FROM: AMHI Center Building Storage Addendum 2
TO: Prospective Bidders, Suppliers, and Other Parties
RE: Addendum No. **2 (Two)** to the Bidding Documents

AMHI Center Building Storage, Augusta ME

ADDENDUM 02 - 10.27.2021

SF-201

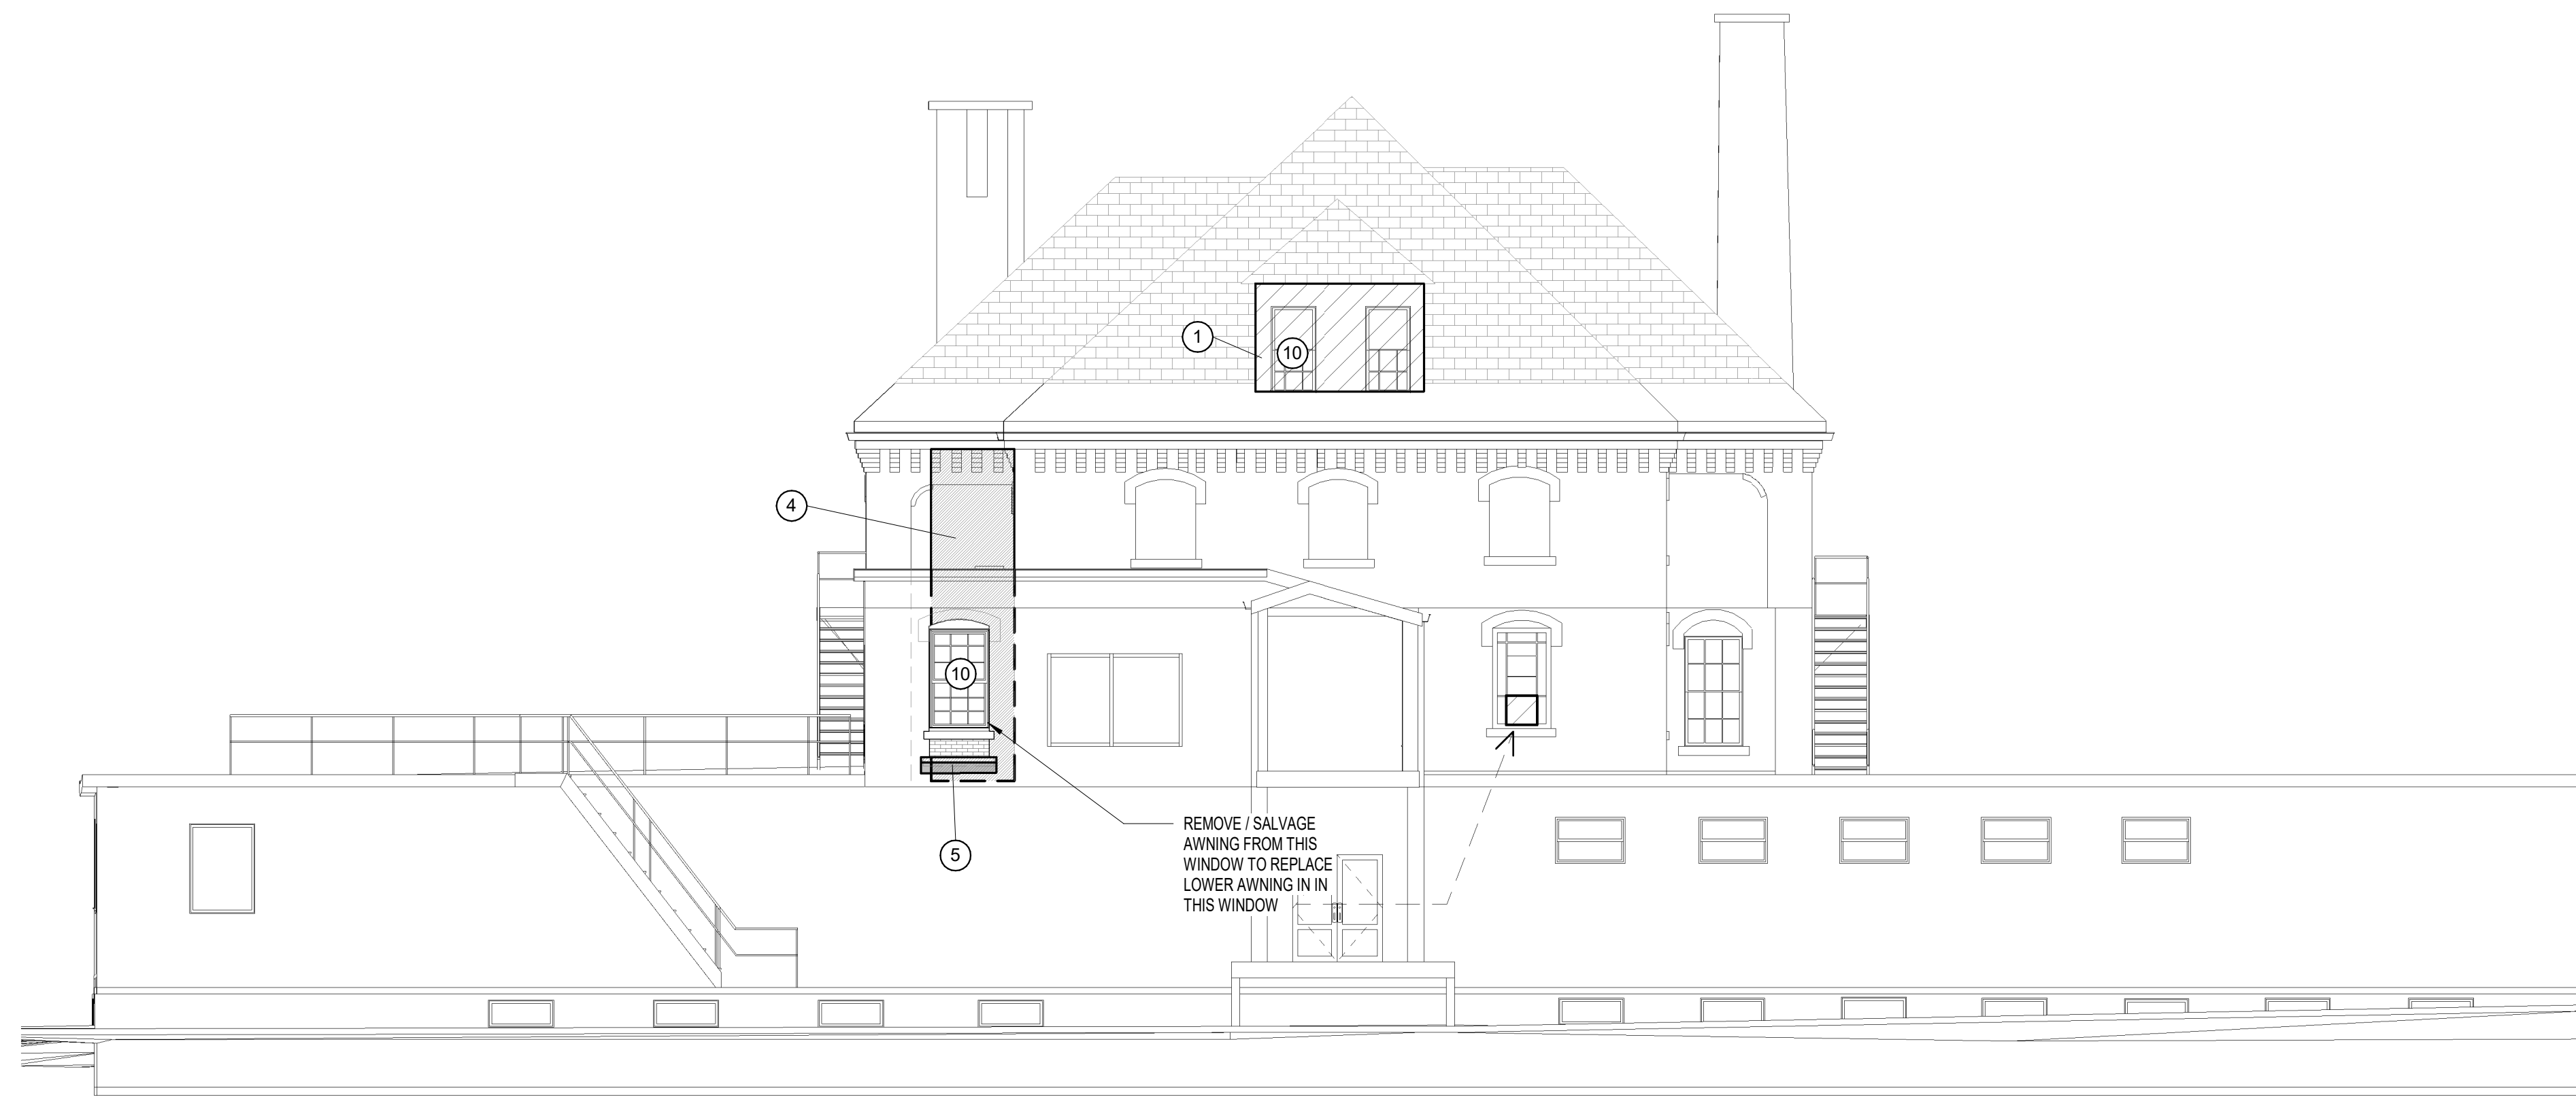
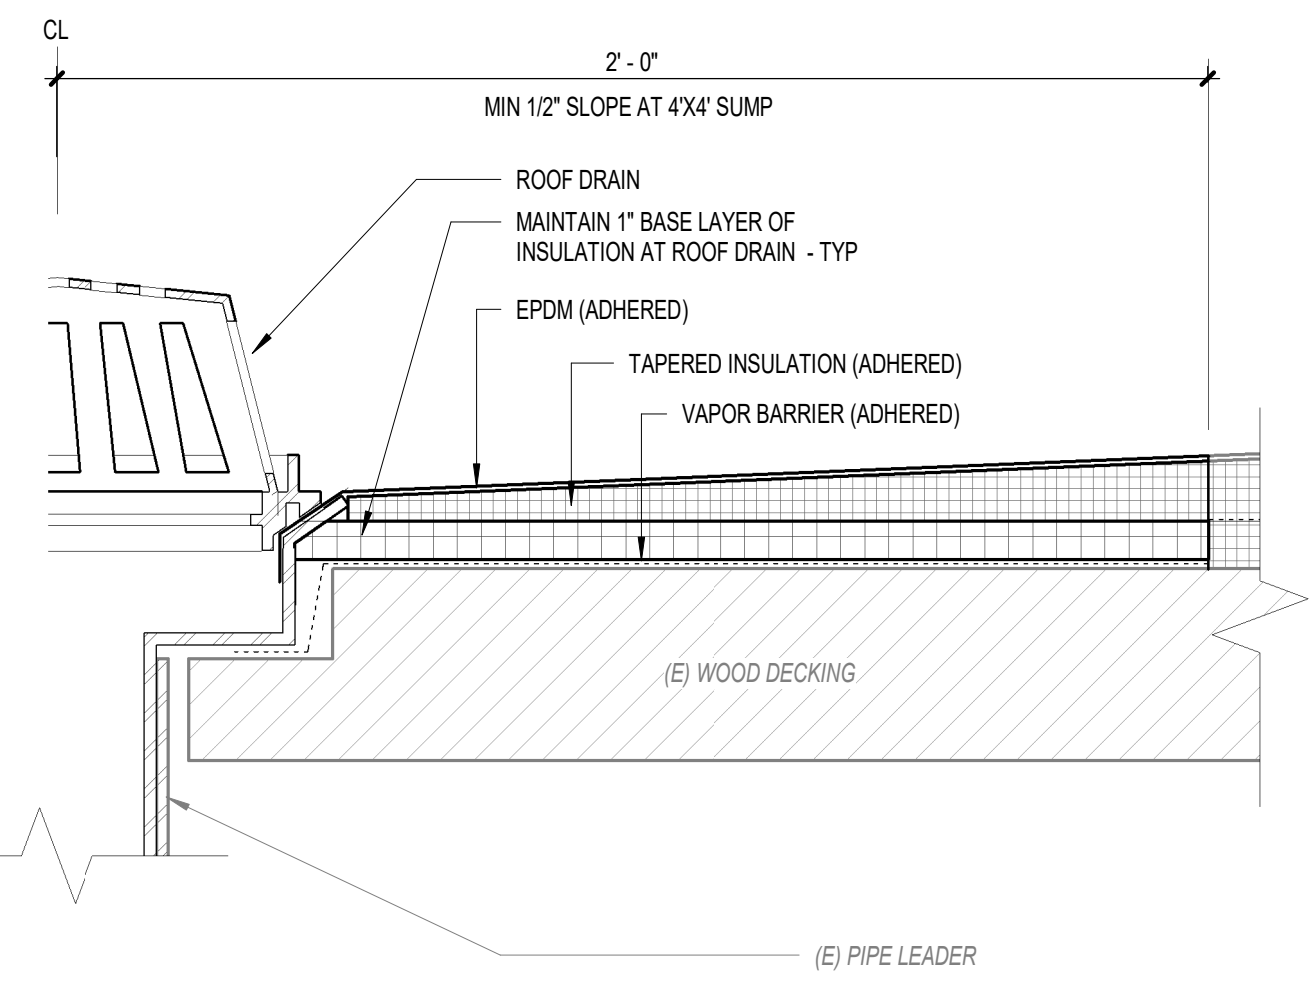
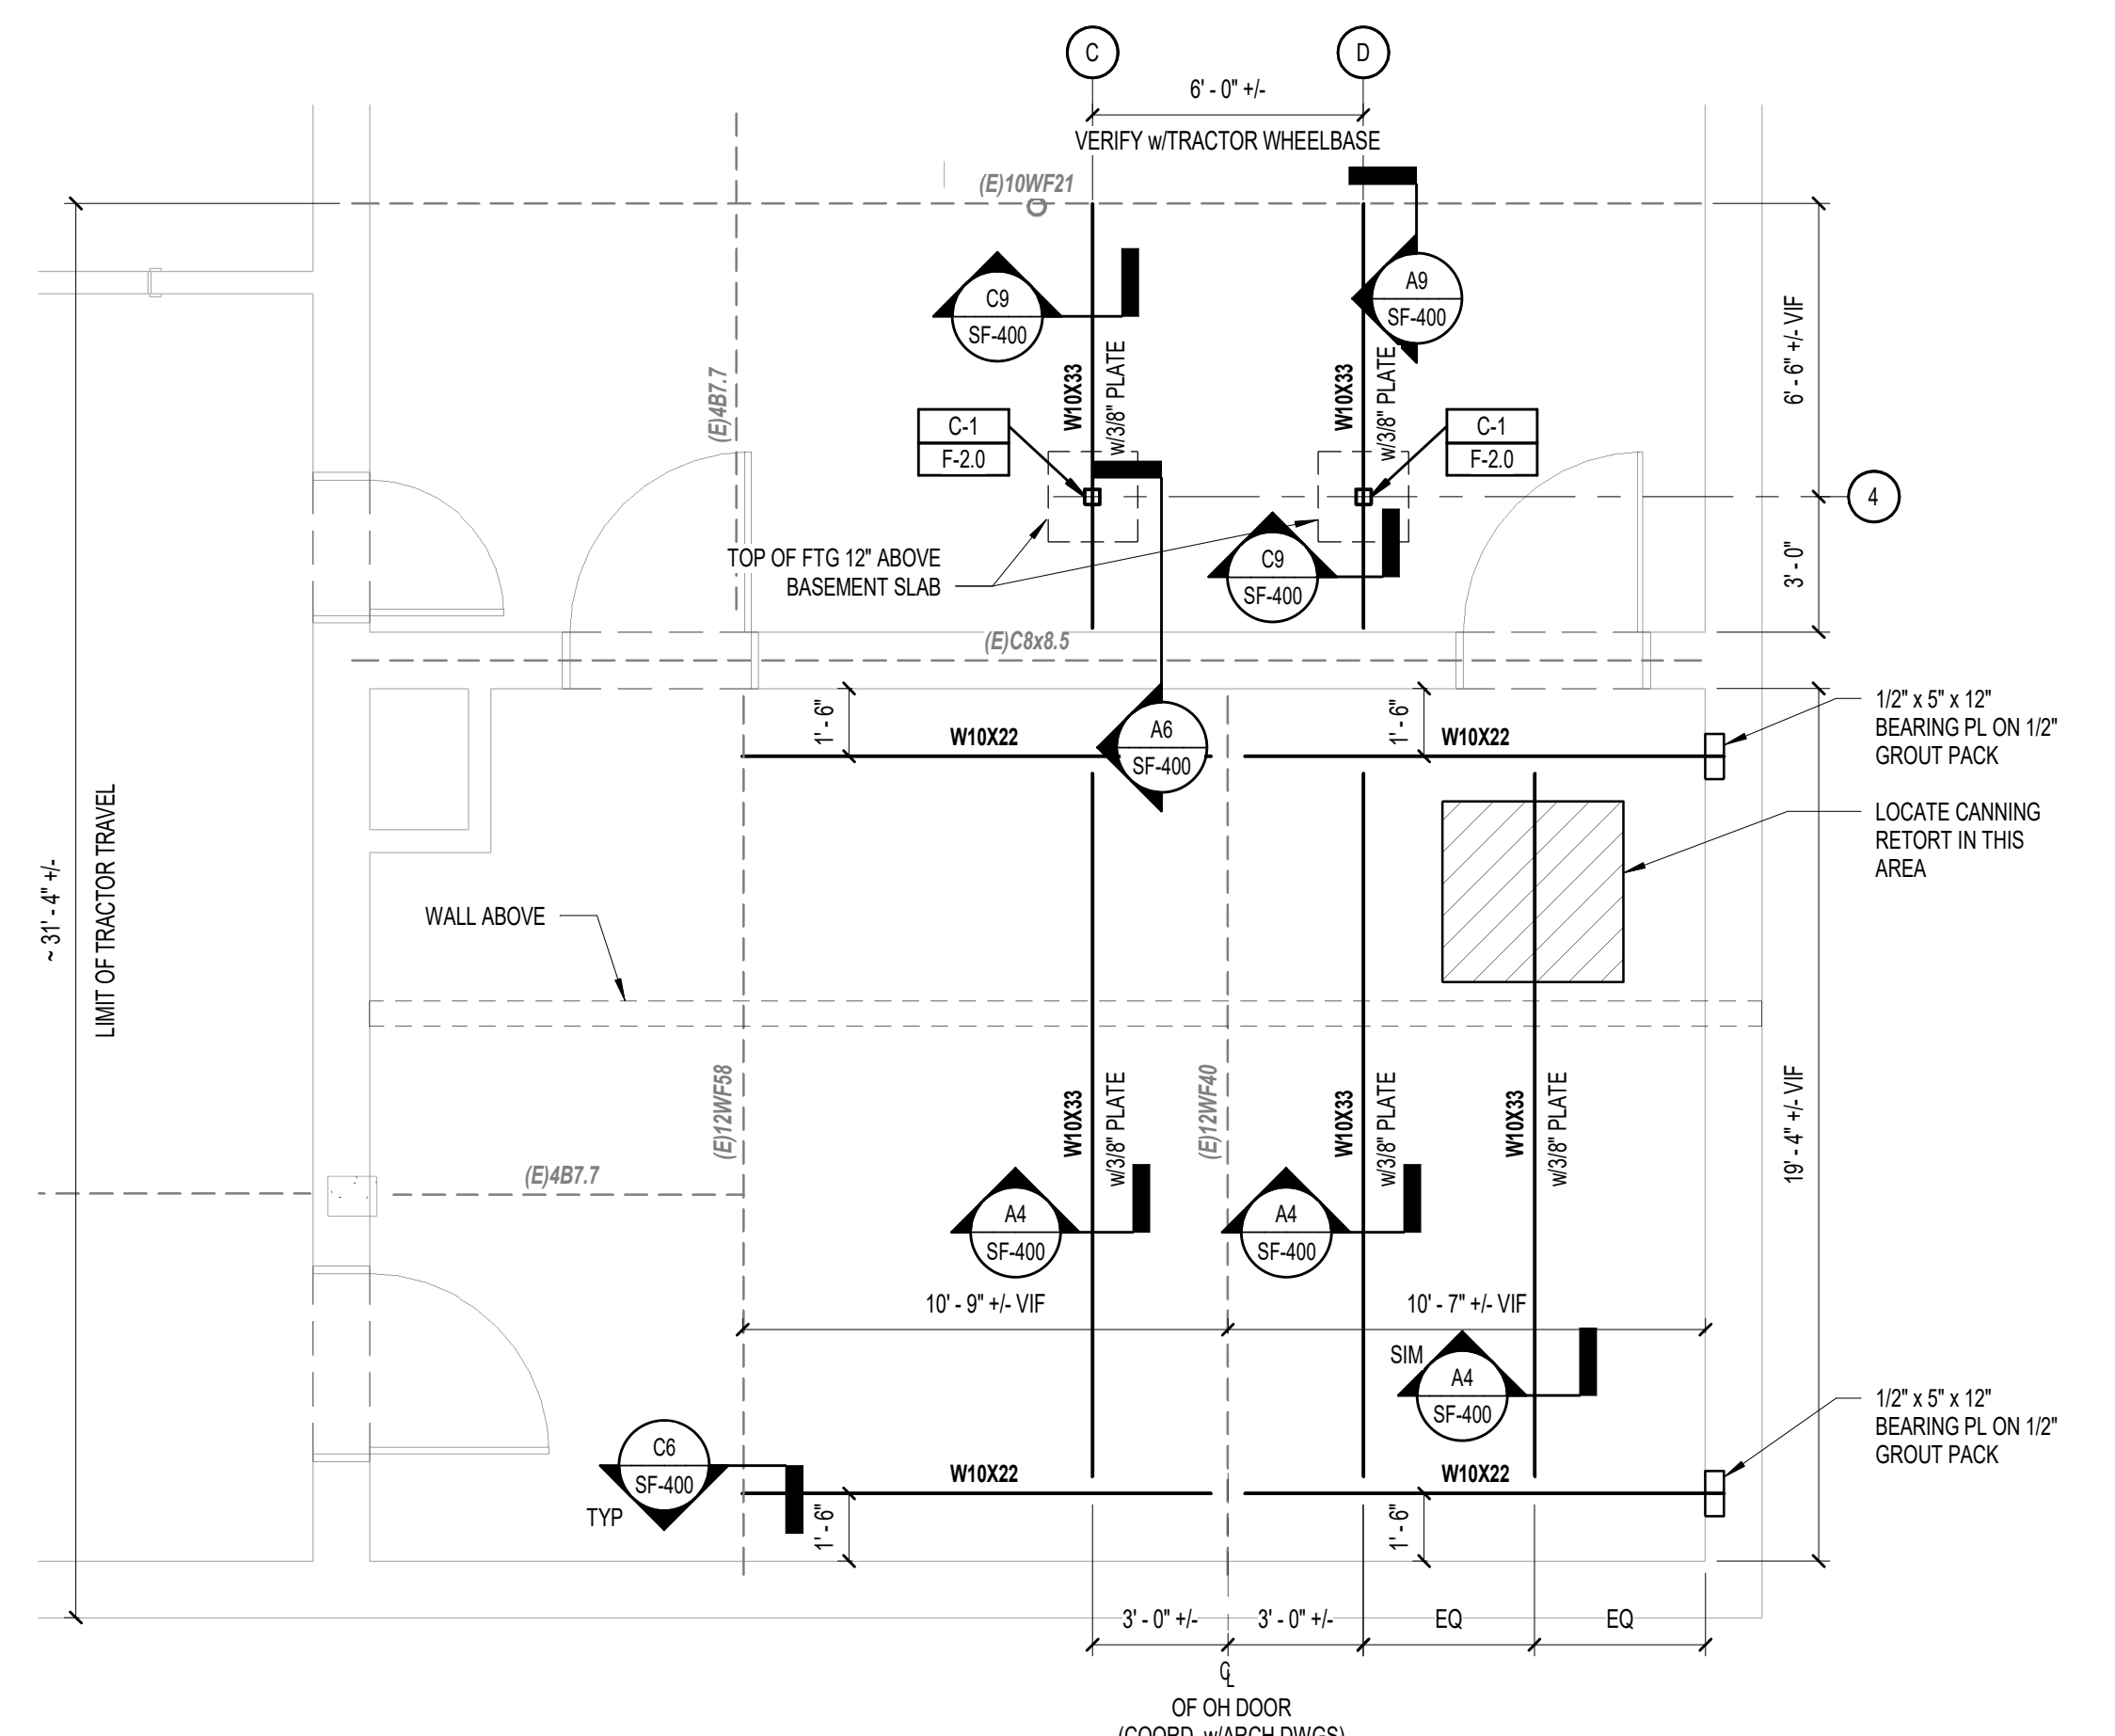
5	PC Construction			Please confirm the Contractor is responsible to provide builder's risk insurance for the Work itself?	AEI: that is correct.
6	PC Construction			Please confirm that the Owner will maintain property insurance on the existing State-owned buildings and that Owner shall be responsible for all deductibles associated with losses to the existing State-owned buildings?	AEI: that is correct.
7	PC Construction			Please note section E1 on Drawing SF-500. Please provide a TOC or TOS elevation for both the lower and first floor level. [PED]	AEI: Basement slab to first floor slab = ~ 8'-6".
8	PC Construction			Please note Allowance item 1: Replace Wood Trim and Siding at Dormers Noted on Contract Documents (Masonry note 1, Sheet SF-110, SF-200 and SF-201). This allowance is listed on the bid form as a Lump Sum Unit, with a quantity of one. The drawings as noted in the allowance item, shade the areas of work where the allowance shall be applied, however they lack sufficient detail needed to accurately price the work that is required to be performed: dimensions, siding & trim materials, details, etc. To make the bid comparison's accurate, we feel that the Owner and A/E should provide an allowance amount for this bid item, which would be carried by all the bidders. The same consideration could be applied to each of the lump sum allowances (numbers 3 and 5).	AEI: See Sheets SF-200 and SF-201 for revised Note 1 of the ROOF AND EXTERIOR FAÇADE CONDITIONS.

9	PC Construction			Please note drawings A3.01, A3.02, SF -200 and SF-201. To accurately determine means and methods to access the exterior of the building, the levels of each floor would be helpful. Please provide elevations for each of the floor levels of the building.	AEI: Basement level ~ (-)8'-6", First Floor Level ~ 0'-0", Second Flr level / low roof ~ 12' cave height at upper roof ~ 37'-0" above 1st floor level. Contractor is required to field veri these elevations.
10	Blaine Casey Construction			The Architectural plans provided do not include any cross sections of the areas to be renovated or any elevations marked with floor/wall heights other than for the Loading Dock area as shown at E5/A303. Are all of the wall heights in the areas to be renovated similar to what is shown there (13'-1½" Floor to Floor). The only cross section I could see in the Structural Plans was at E1/SF-500. This detail shows a height from 1st Floor slab to the bottom of the 2nd Floor fluted slab above of 8'. Please provide more details regarding the wall heights.	CWS: For pricing purposes, the finish floor to underside of deck height within the northern half of the overall plan is 12'-6". The finish floor to underside of deck height within the southern half of the overall plan is 13'-8".

- 1 THE GABLE DORMERS FACAGE IS SIDED WITH A WOOD TRIM AND WOOD PANEL INSETS. THE WOOD TRIM WRAPS THE SIDES AND TERMINATES AT THE COPPER SKIRT FLASHING. IT IS THE PROJECT'S INTENT TO REMOVE AND REPLACE ALL EXISTING WOOD TRIM AND SIDING AT THE DORMER LOCATIONS INDICATED.
